Intel® Pentium® 4 Processor on 90 nm Process

Specification Update

February 2006

Document Number: 302352-026

Figure 3. Intel® Pentium® 4 Processors 571, 561, 551, 541, 531 and 521^Δ Supporting Hyper-Threading Technology on 90 nm Process in the 775-Land LGA Package

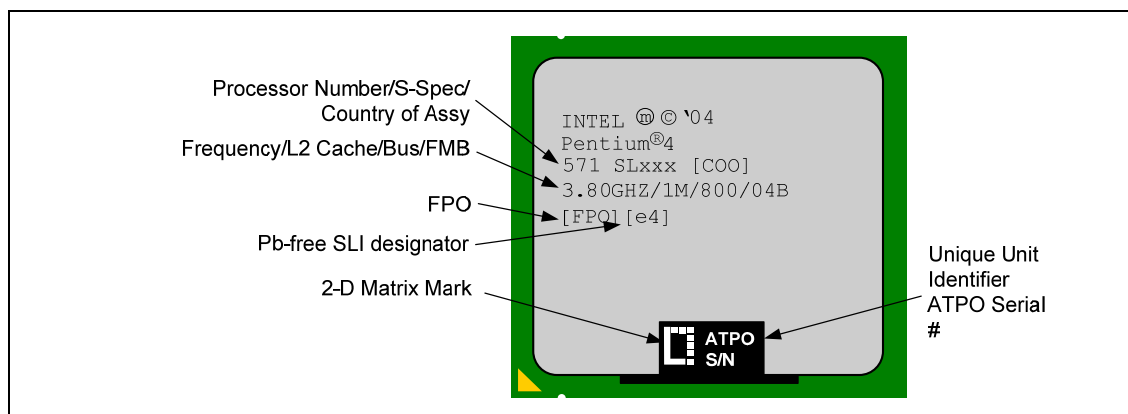
| Revision Number | Description | Date |
|-----------------|---|-------------------------------------|
| -025 | <ul style="list-style-type: none"> Updated erratum R17 and added errata R111-R114, updated processor identification table, updated figure 3 and figure 4 to show Pb-free marking | January 2006 |
